39T-08502/Z-7489/OZ-7510

TO:	CHAIR AND MEMBERS PLANNING AND ENVIRONMENT COMMITTEE
FROM:	GEORGE KOTSIFAS DIRECTOR OF BUILDING CONTROLS AND CHIEF BUILDING OFFICIAL
SUBJECT:	APPLICATION BY: KENMORE HOMES (LONDON) INC. 255 SOUTH CARRIAGE ROAD & 1331 HYDE PARK ROAD PUBLIC PARTICIPATION MEETING ON MARCH 26, 2012

KENMORE HOMES (39T-08502) REDLINE AMENDED DRAFT PLAN

Kenmore's 2010 Proposed Street Pattern

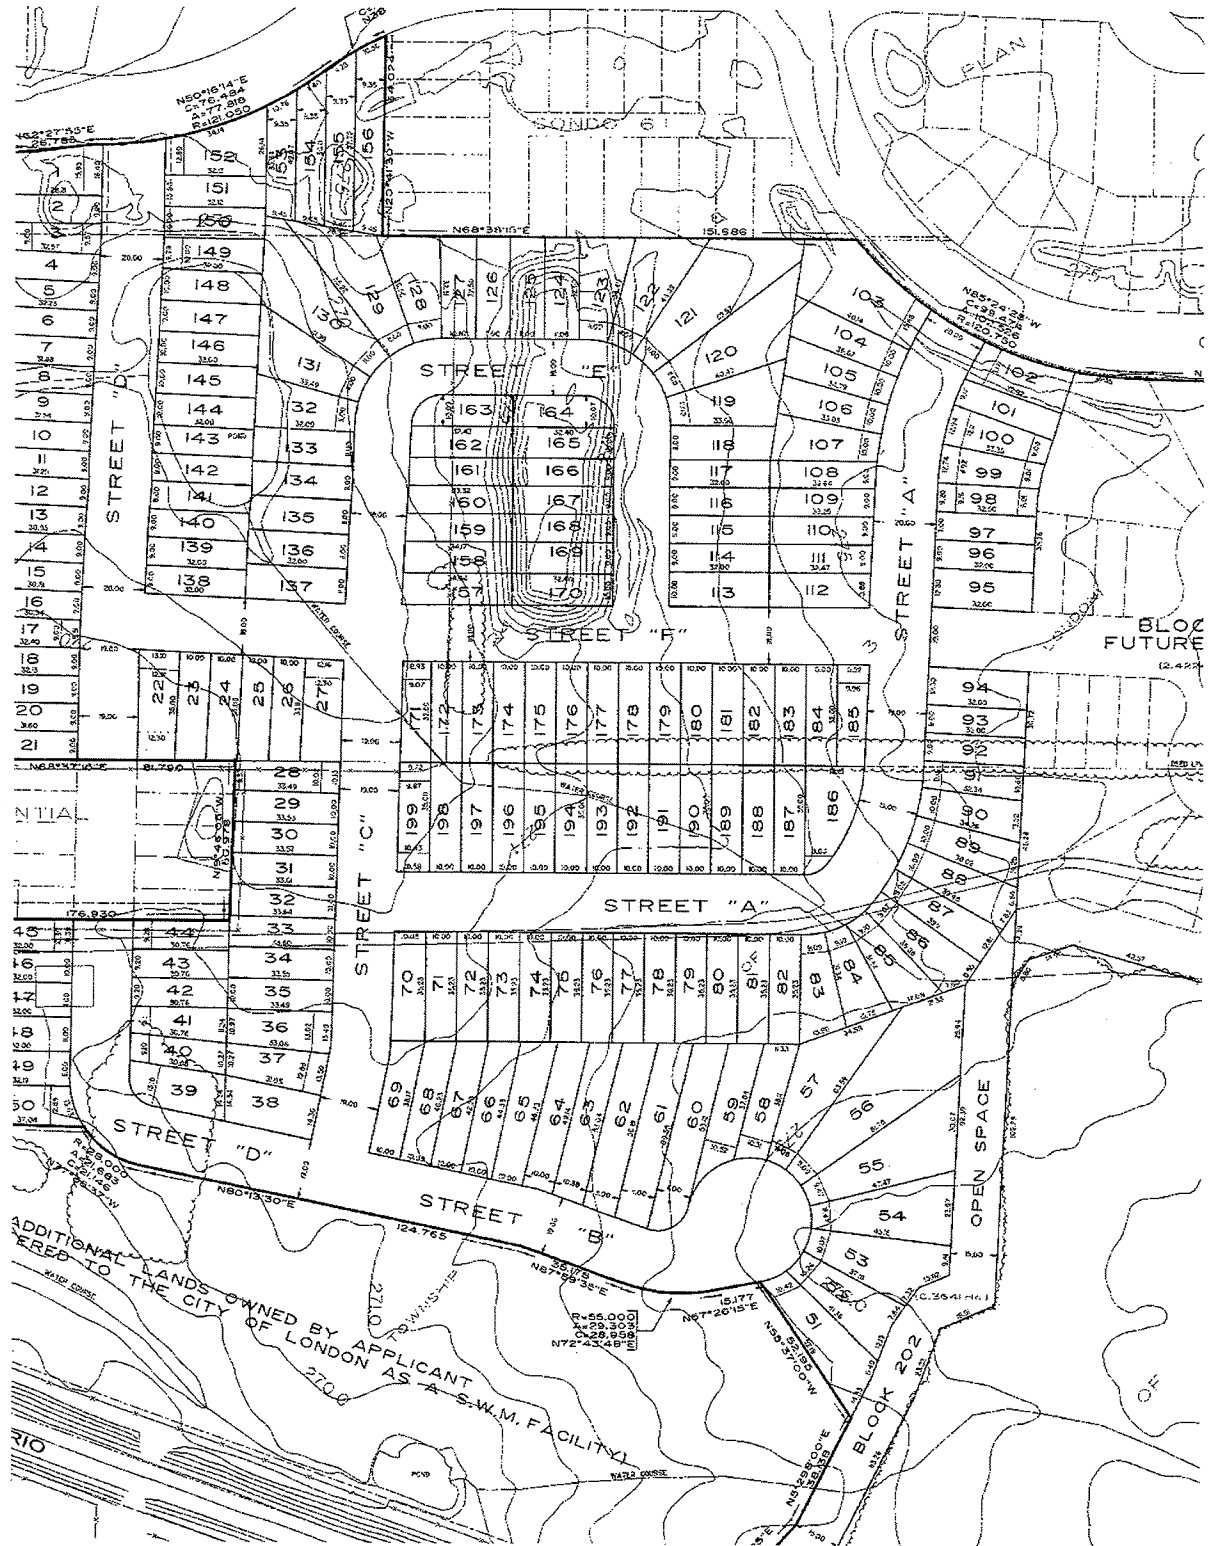
Development Planning staff noted in their January 31st report to BNEC that a redesign to the internal road pattern should be considered in order to provide for an overall improved vehicular and pedestrian circulation for the subdivision and the area. Staff recommended that the draft plan be redlined so that the easterly limit of Street B be connected to Street A. It is staff's position that this will provide for better vehicular and pedestrian circulation and in the long term it will provide for a continuous street from Coronation Drive to South Carriage Road. It should also be noted that staff's redline amendment is based on the original road pattern submitted by the applicant in 2008.

Mr Knutson noted in both his May 16th and June 14th correspondence that for reasons relating to marketability, livability and value, the original Kenmore plan is their preferred plan noting that there is no City policy directing any particular street pattern. They also note that their original design results in a shorter road length by approximately 82 metres which represents greater value with its enhanced privacy and reduced traffic. Conversely, staff note that an increase of 82 metres of street length would provide for an increase of saleable lot frontage which could result in greater returns for the owner.

EESD Transportation staff have reviewed both designs and they have concluded that the subdivision design proposed by Development Planning will not generate any noticeable increase in traffic volume or create higher speeds than the applicants' proposal. It is their opinion that with the City's revised street pattern traffic volume will be more evenly spread between the local streets because the loop design provides more access to the southerly part of the subdivision. The greatest impact will be on Street 'C' which, until Street 'D' is extended through the remnant parcel, is the only access to the southerly part of the subdivision proposed by the applicant.

Staff's Proposed Realignment of Streets A and B

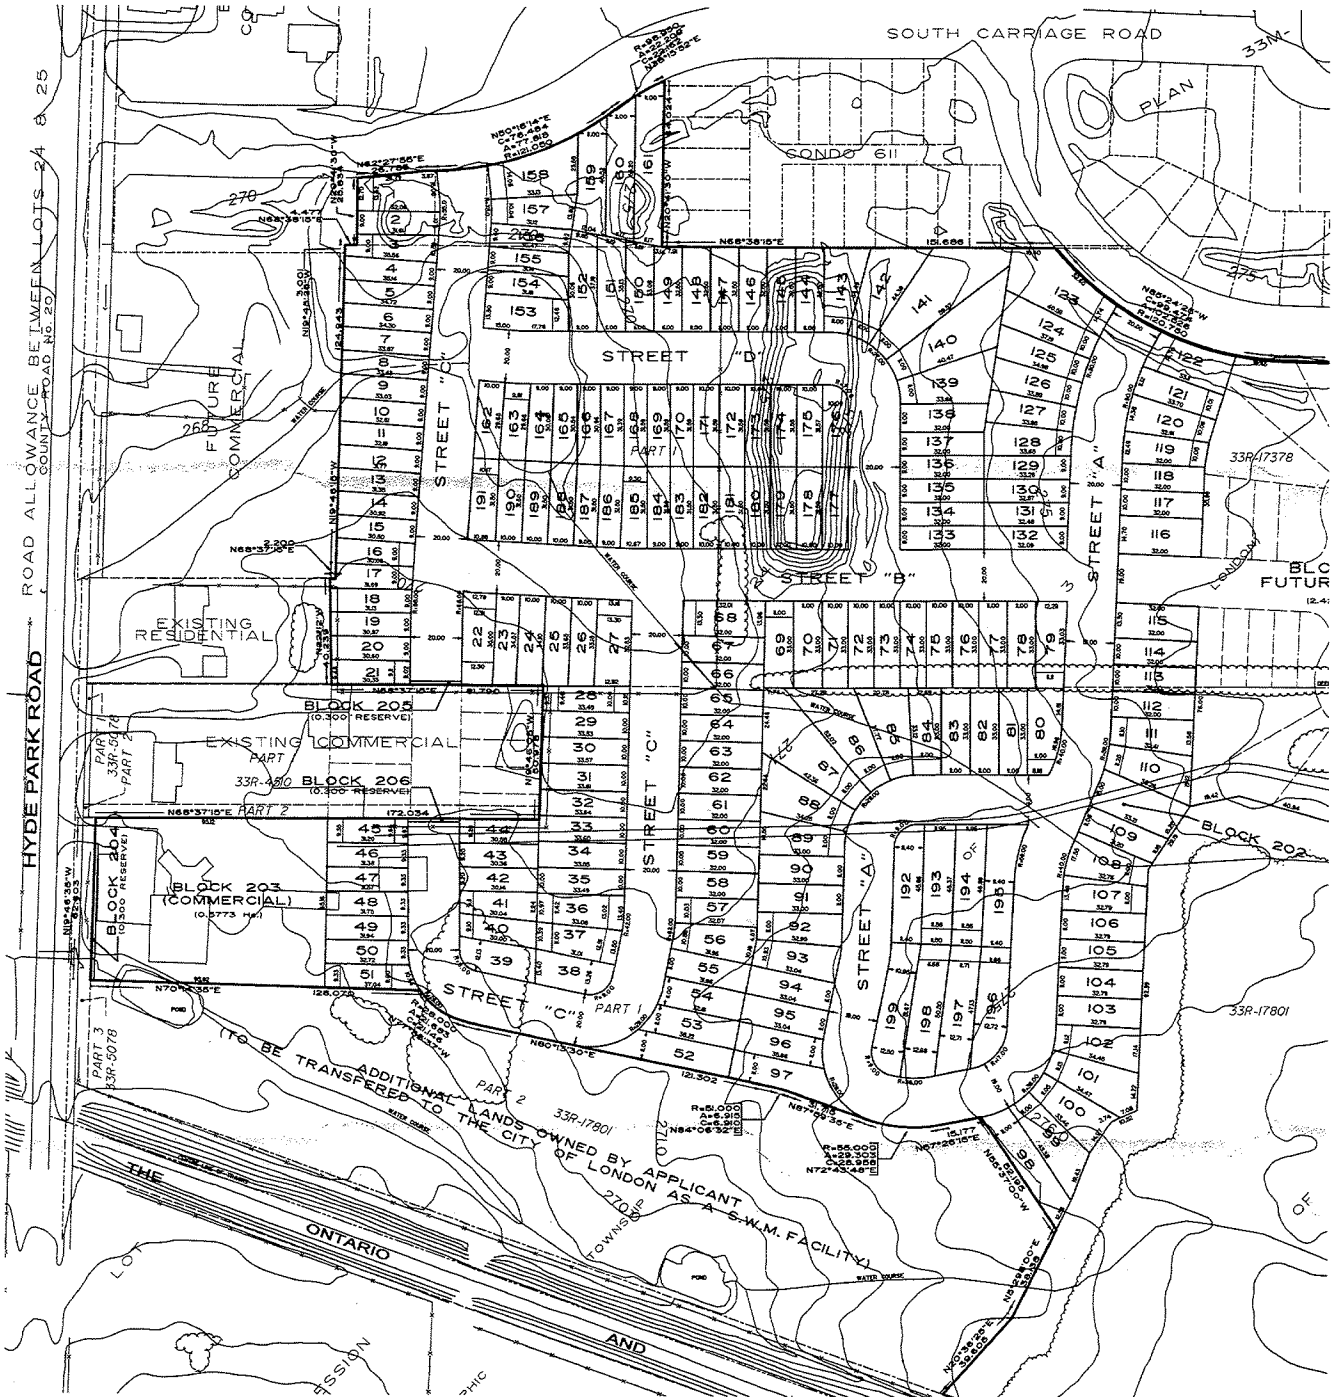
The applicant continued to have issues with staff's redline amendments and as a result staff worked with the applicant to review other design options for this draft plan. Based on these discussions the applicant proposed a revised design which was circulated to the public on December 14th 2011.

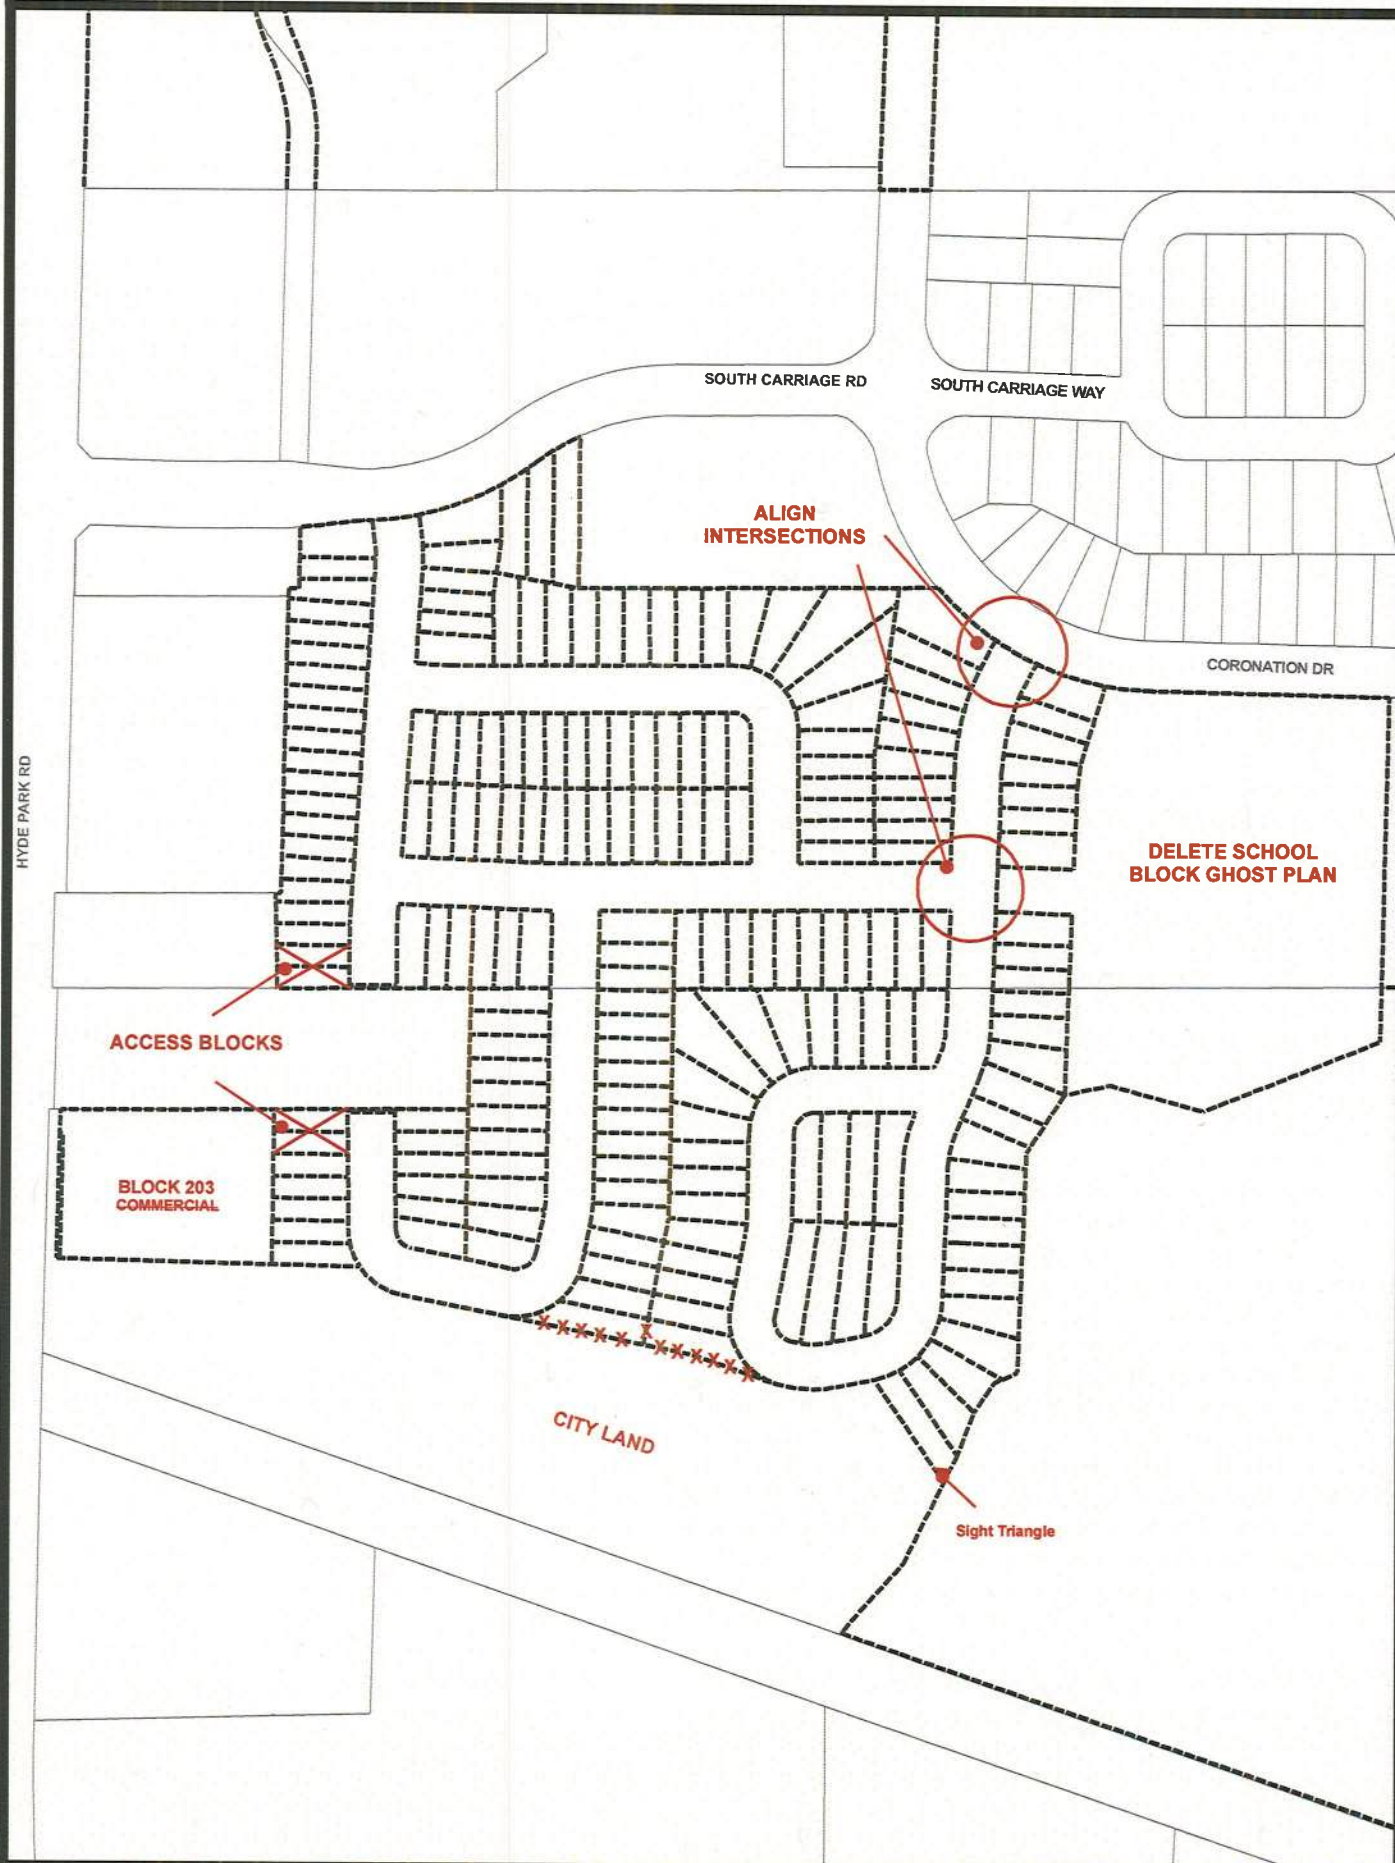
The main differences between the most recent revised design and the applicants original proposal is a revision to the design of the crescent(Street "D") at the north limit of the plan and the inclusion of a "P" loop Street (Street "A") at the south east portion of the plan. The proposed "P" loop street eliminates the need for a cul-de-sac at this location and continues to provide for a window street frontage to the SWM block. The main issues relating to this latest design was how to accommodate overland flows to the SWM facility and how to accommodate the pathway which runs along the northern boundary of the swm block.

The original design included a window street at this location (across the full frontage of the SWM block) and the revised design eliminated a portion of the window street. This change impacts the overland flow routes, the outlet to the swm pond and the pathway location. In discussions with the applicant's agent and his consulting engineer it was concluded that the most appropriate way to maintain overland flows and to eliminate any impact to the outlet was to remove lots 52 and 97. The removal of lots 52 and 97 also provides sufficient room to address

the location of the multi-use pathway. Based on the above, staff recommend approval of this third alternative design with a redline amendment to remove lots 52 and 97. To ensure the overland flow route and pathway function it is also recommended that this area be zoned OS4. Should Council not support staffs recommendation, staff recommend that their redline revision to the original subdivision design (see page 14) be approved subject to the original conditions of draft approval as noted in the January 31st staff report.

Redline Revisions to Draft Plan

- Eliminate lots 52 and 97
- Create access blocks for lots 20 & 21 and 45 & 46
- Revise streetline radii to meet City standards on all roads within this plan
- Revise Street 'A' (adjacent to Lot 192-195) to connect into Street 'A' at 90 degrees with a minimum 6 metre tangent
- Adjust alignment of Street 'A', north and south of Street 'B' to accommodate a taper from 20 metre right-of-way width to 19.0 metre right-of-way width south of Street 'B'
- Revise lands outside this plan to be owned by the City and remove note "Additional lands owned by the applicant to be transferred to the City"
